SERVICE BULLETIN

TS-120S

SUBJECT: TS-120S VFO STABILITY

DATE 6/6/80

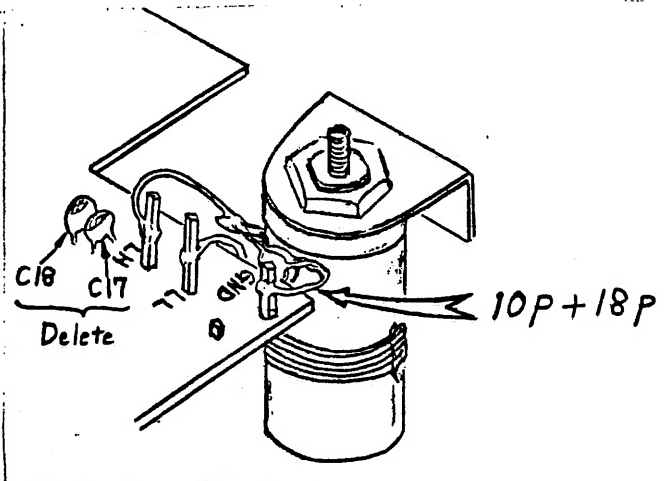
VFO drift characteristics may be improved by changing component values and location in the VFO.

This change applies to serial numbers before 0010001.

1. Remove the VFO unit by four 3mm hex head bolts.
2. Withdraw out the front panel and unplug the leads.
3. Remove the VFO cover by five Phillips head screws.
4. Remove C17, C18 from the PCB. These may be cut flush to the board.
5. Reposition the Ground terminal for the Variable Capacitor by heating the post and pushing it through to the opposite side of the PCB.
6. Install paralleled 10pF Green and 18pF Yellow caps from the bottom tank coil terminal (LH) to the modified Ground post. Position the caps near the coil, not the PCB. Make certain the ground lead doesn't touch the coil or coil mounting.
7. To reassemble, perform steps 3,2,1. Snug all VFO case screws. A later complaint of frequency jump would indicate a loose VFO shell.

NEW PARTS: 10pF CC45SG1H100J
18pF CC45RG1H180J
